E3610A-06E-S

S E R V I C E N O T E

E3610A - Manual DC Power Supply

POSSIBLE SHOCK HAZARD

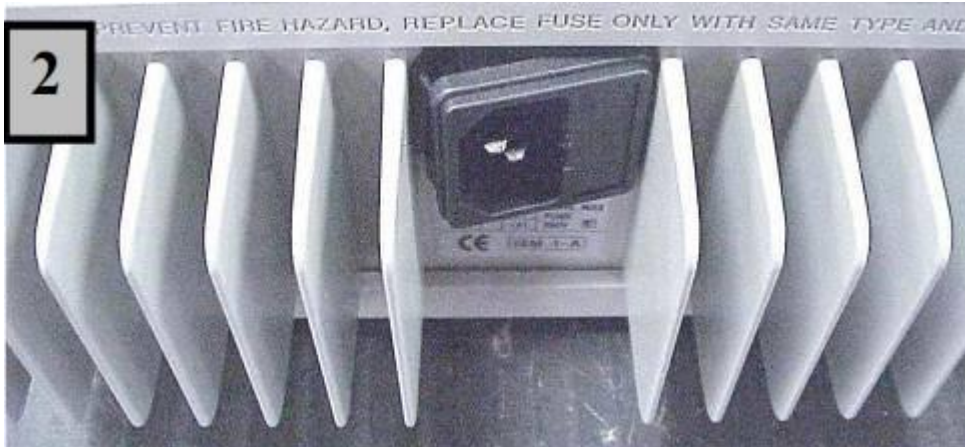
If the AC line cord is forcefully pulled in a side-to-side direction the AC module can be pulled out of the rear heat sink, exposing the conductors that carry AC line voltage.

LOOSE AC MODULE

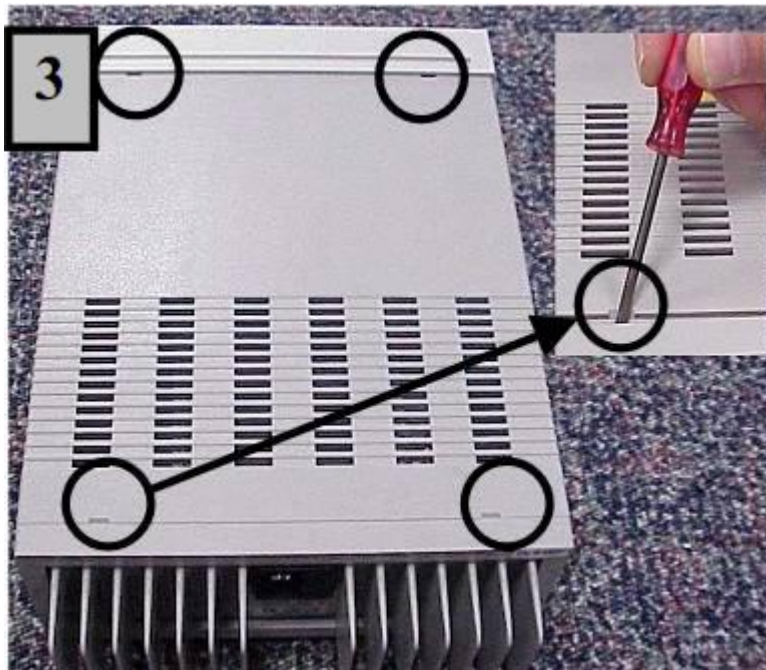
1. Make sure line cord is removed from outlet.
2. With line cord securely inserted in AC module as shown, pull forcibly (2 times) in direction of arrow.

1. If the AC module pulls out from unit as shown it will need to be replaced.
2. If the AC module remains in place it does not need to be changed. Put a mark on the AC input label in the lower left hand corner with indelible ink to indicate that AC module has been checked. This label can be found below the AC module.

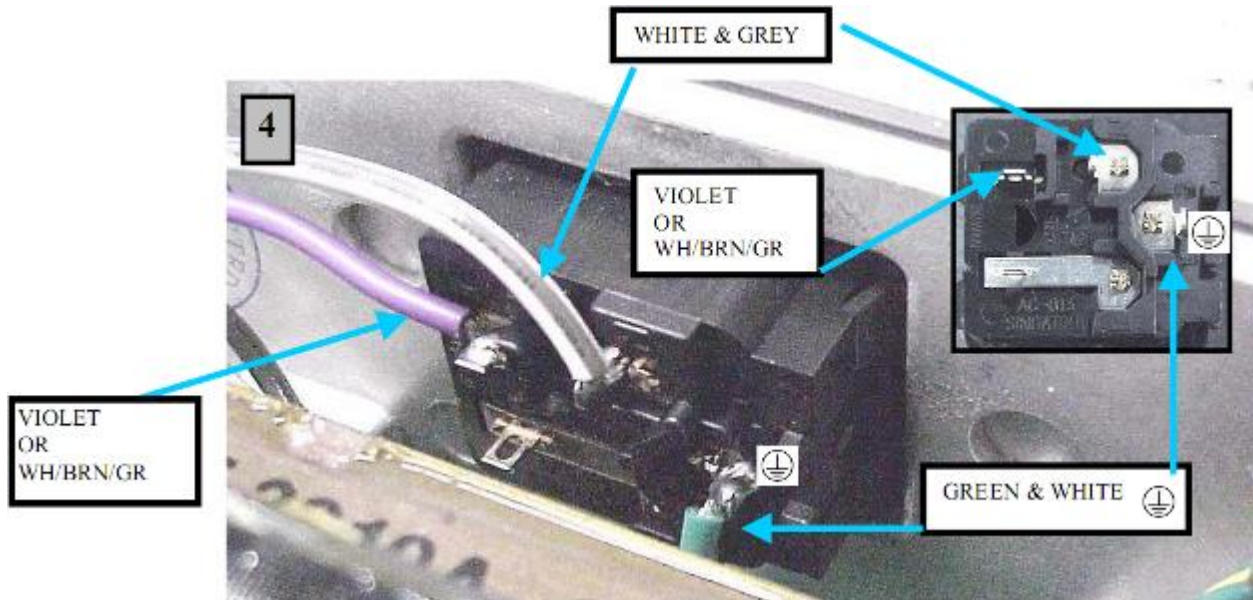
REMOVE COVER by prying rear bezel and front panel away from cover in four places as shown. Then lift cover off unit.

REPLACE MODULE with P/N 5065-6978. Before soldering perform “TEST FOR LOOSE AC MODULE” as shown in the picture above. This will confirm that the new module is secure. Solder wires and **REPLACE FUSE**.

CAUTION: WIRING MUST BE CORRECT OR HEAT SINK COULD BE AT LINE POTENTIAL.

CAUTION: MAKE SURE SAFETY GROUND  IS ATTACHED TO HEAT SINK.
